AGENDA FOR REGULAR MEETING VILLAGE OF TINLEY PARK PLAN COMMISSION

**Item #1 WORKSHOP: BREMEN STATION – 6775 SOUTH STREET, VIN PROPERTIES LLC
SITE PLAN APPROVAL, SPECIAL USE, VARIATIONS AND PRELIMINARY/FINAL
PLAT APPROVAL**

PLAN COMMISSION STAFF REPORT

Consider granting Site Plan Approval and recommending that the Village Board grant the petitioner, Vince Tessitore on behalf of VIN Properties LLC, Final Plat approval, a Special Use Permit to allow Accessory Residential Uses where street-level commercial is required and Variations from the Zoning Code to construct a 60,311 square foot five (5) story mixed-use development called Bremen Station consisting of 39 residential apartments (20 one-bedroom 19 two-bedroom) and 4,579 square feet of retail space on the first floor for the property located at 6775 South Street in the DC (Downtown Core) Zoning District.

Above: Basement Plan with Vehicle Parking, Bike Parking, Mechanical and Storage Space

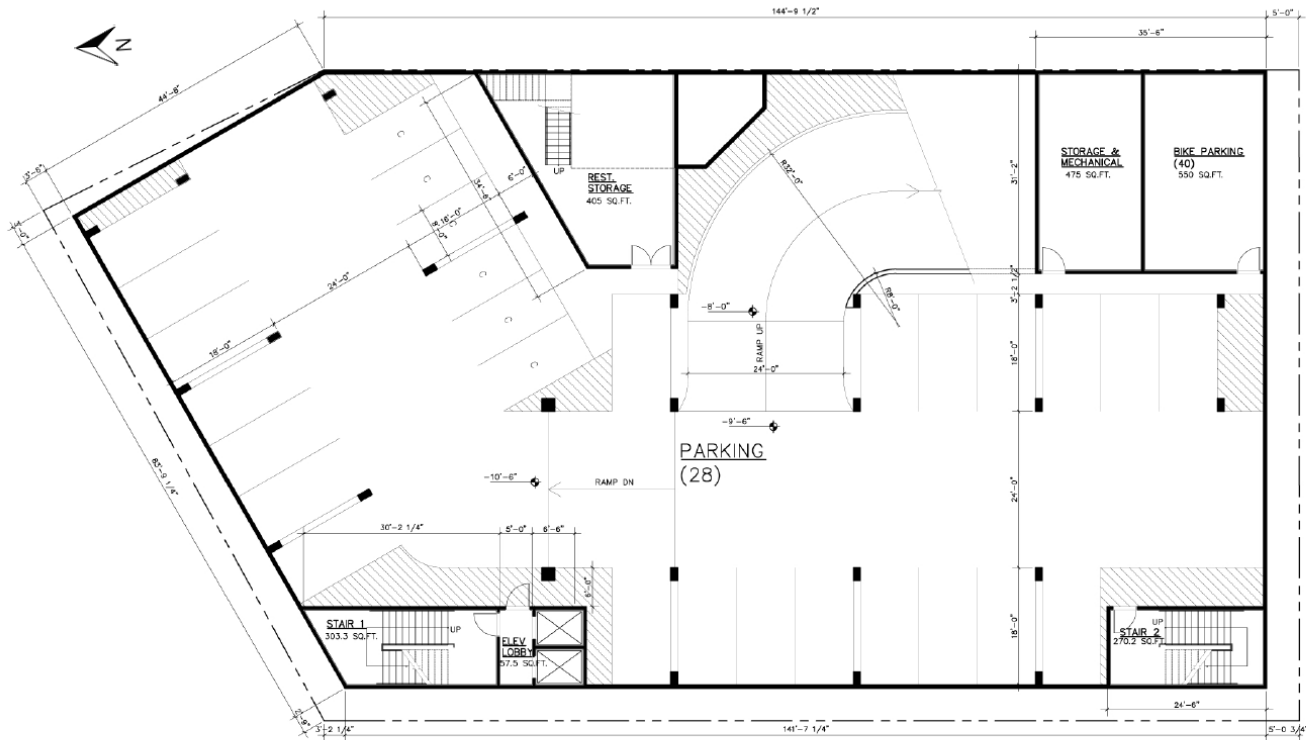
A seven foot (7') wide outdoor dining space has been included along the South Street frontage for use by the restaurant tenant. This dining area will be located entirely on private property. The outdoor dining area will be delineated from the right-of-way by a three-foot (3') high fence matching in material and design to the residential balcony railings. The Legacy Code permits a private frontage to have a dining alcove extend up to 50% of the frontage width. This proposed dining alcove will extend the entire width of the South Street frontage and would require a setback Variation to extend the entire building frontage. The result is that the first floor of the building is set back as

much as 7.8 feet (7.8') instead of the maximum of five feet (5') that is permitted by code. Staff supports the proposed outdoor dining design which allows the restaurant to have a larger and more practical outdoor dining area along South Street. It also avoids sharp façade changes that a dining alcove can cause on a relatively short building frontage.

Open Item #3: Discuss a Variation to permit the front yard building setback to be a maximum 7.8 feet to allow an outdoor dining to be placed the entire length of the South Street frontage instead of a maximum of 50% of the frontage.

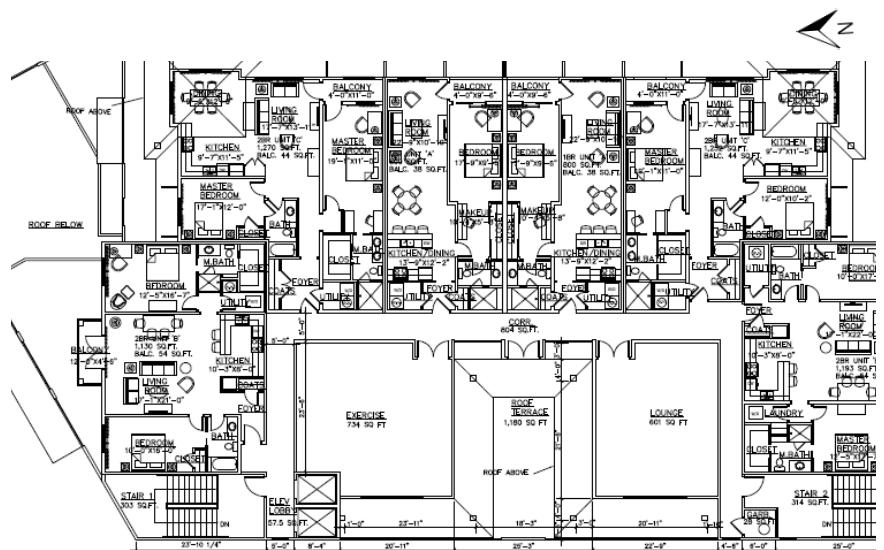
The proposed Bremen Station development will result in the removal of a fence and some parking spaces currently used by the Tinley Park – Park District's Vogt Visual Arts building. While this parking encroaches onto the subject property, Staff recommends that the Petitioner work with the Tinley Park – Park District and ensure that their site is repaired effectively and that it does not disrupt their operations. The petitioner has indicated they have talked with the Tinley Park – Park District and have proposed to repair and stripe five (5) parallel parking spaces on their property. No formal acknowledgment of contact or approval has been supplied from the Park District. In addition, the Petitioner has not proposed a replacement for the existing fence between the properties. If there will be no fence or barrier between the two (2) properties, staff recommends creating a barrier curb or grade difference between the Bremen Station sidewalk and the parallel parking spaces on the Vogt Visual Arts building to act as a curb stop and separation between pedestrians and vehicles. The applicant has indicated they agree with this and that it will be addressed within their final grading plans. Staff has recommended a condition be placed on the site plan approval that a minimum six inch (6") grade difference is maintained between the Park District parking and the Bremen Station sidewalk.

Open Item #7: Formal correspondence and approval from the Tinley Park – Park District has not been submitted indicating they understand the proposal and agree with the proposed five (5) parallel spaces to be replaced on the Vogt Visual Arts property by the Petitioner.

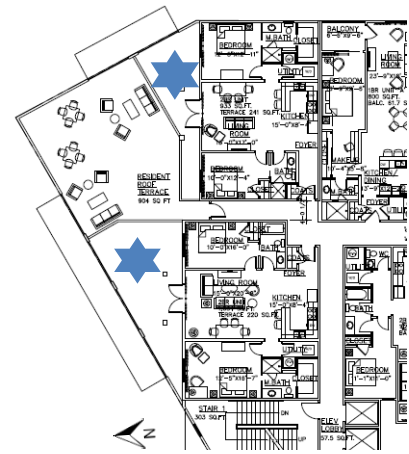
Floors 2-5 are all setback up to 44 feet from the front property line. This setback of the floors is due to the odd triangle shape of the vacated right-of-way parcel and the difficulties with creating apartment layouts with that shape. The maximum setback per the Legacy Code is five feet (5'). This is to create a pedestrian-friendly and inviting street wall in the downtown and avoid setbacks. The odd lot shape and use of a shared balcony on the second floor make good use of space that would otherwise be difficult to develop. Because the building will be set back 44 feet on floors 2-5, a variation is required.

Open Item #9: Discuss Variation to permit balconies to encroach five feet (5') into the rear yard setback where balconies are not permitted to encroach.

Open Item #10: Discuss Variation to allow floors 2-5 to be setback 44' instead of the permitted maximum of five feet (5').

Above: Second floor, private fenced patio areas (blue stars) next to the shared rooftop terrace.

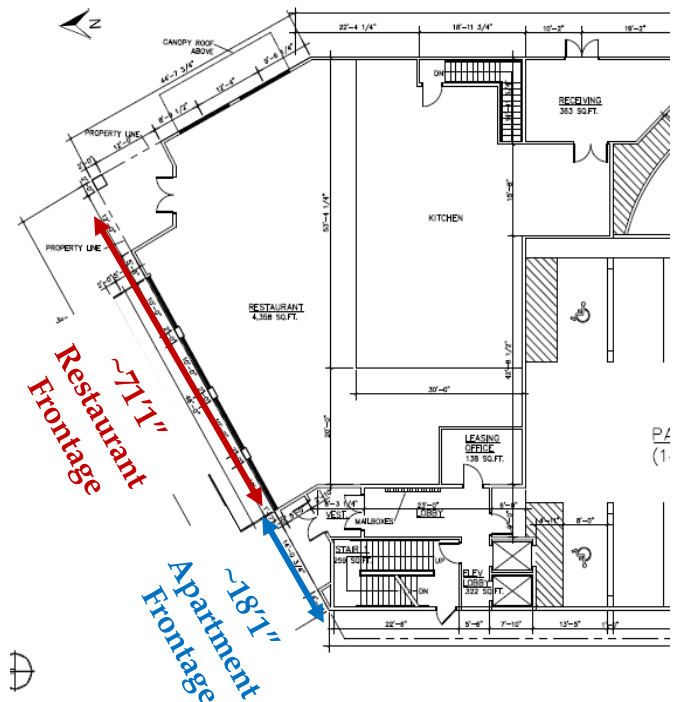
The Petitioner is proposing to locate their common apartment entrance vestibule, lobby, and leasing office on the first floor along South Street. The Legacy Code indicates that the South Street frontage requires street-level commercial and apartment amenities are only permitted with Special Use Permit approval. The apartment entrance and amenities could be relocated off of the 67th Court frontage, where street-level commercial space is not required. The Petitioner has indicated this is due to a set interior layout and inability to relocate the stairwells and elevators to the east side along 67th Court. The apartment entrance and amenities utilize approximately 18' 1" (21.23%) of the total frontage which is approximately 85' 2". The remaining frontage will be utilized by the restaurant tenant space.

The proposed on-site leasing office is a small 138 square foot space that is expected to be used as an appointment only office. However, if there is an on-site office regardless of how often it is used, a bathroom is required to meet the applicable plumbing codes. Sharing a restroom with the restaurant is not an acceptable solution as the spaces may have different uses, hours of operation and can change ownership. If the office is to remain, a bathroom will need to be installed. While an on-site leasing office is preferred, due to the size of the development, it may not be needed. If it is determined the on-site office is not needed, the resulting space could be utilized as a package delivery/storage area for residents or incorporated into the restaurant space.

Open Item #12: Consider if an on-site leasing office is necessary for the proposed development. If the on-site office is maintained, a restroom will need to be added.

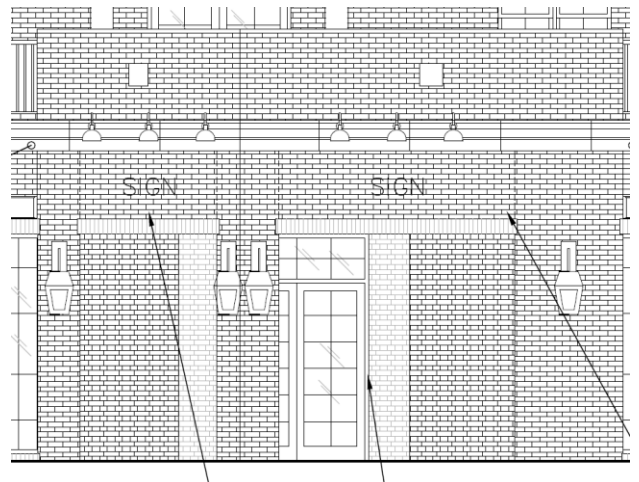
The proposed streetscape is an example of what the Village may like to see in regards to landscaping, trees, benches, and streetlights. However, streetscape plan details for the downtown are currently being designed by a Village consultant. Staff has recommended that the landscape and site plans be subject to meeting all streetscape requirements laid out in the Village's future streetscape plan or any changes the Village sees fit prior to permitting.

Arborvitae, Boxwood, and Wintercreeper have been added along the west side of the property where there is a five foot (5') setback between the Bremen Station property and the Citi Bank property. These were added to soften the view from Oak Park Avenue and prevent cut-through traffic between the properties. Some variety to the plantings could be added to the west façade to help create a more appealing and pleasing view. Additionally, these plantings cannot be maintained easily without going on to the Citi Bank property and clarification is needed on how this can be accomplished.

Open Item #21: Discuss plantings on west façade and maintenance concerns. Increased diversity of species and visual appearance is encouraged.
